APPLICATION NO.	FILING DATE	FIRST NAMED INVENTOR	ATTORNEY DOCKET NO.	CONFIRMATION NO.
10/527,133	03/08/2005	Francesco Sias	4462-13	9432

Office Action Summary

DETAILED ACTION

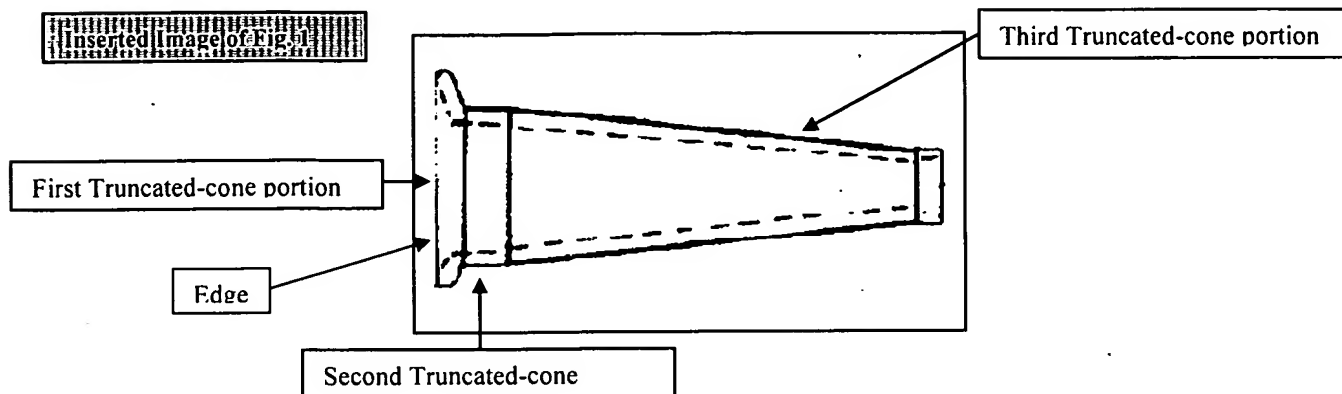
8. **Claims 25-36 and 38-45 are rejected under 35 U.S.C. 103(a) as being unpatentable over Budding 5,464,412 in view of Kaji 6,142,931.**
9. With respect to claims 25-28, Budding discloses an anoscope (fig. 1), comprising a first hollow body 4 (col. 2, lines 44-46) open at opposite ends (fig. 1) and a second hollow body 6

open at opposite ends (fig. 1) shapingly coupled with said first hollow body 4 and arranged coaxially inside said first hollow body 4.

13. With respect to claims 29-31, Budding in view of Kaji disclose the invention as discussed above. Budding further teaches the first hollow body comprises a first truncated-cone portion, wherein first truncated-cone portion is solidly connected with a second truncated-cone portion

that has a progressively decreasing cross-section, wherein the second truncated-cone portion is solidly connected with a third truncated-cone portion that has a progressively decreasing cross-section (see inserted image of fig. 1 below).

14. With respect to claim 32, Budding in view of Kaji disclose the invention as discussed above. Budding further teaches an edge (see inserted image of fig. 1 above) positioned in such a way that it faces the operator during use. It would have been obvious to one of ordinary skill in the art at the time of the invention to have used the first truncated-cone portion as the proximal end closest to the operator in order to load surgical instruments.
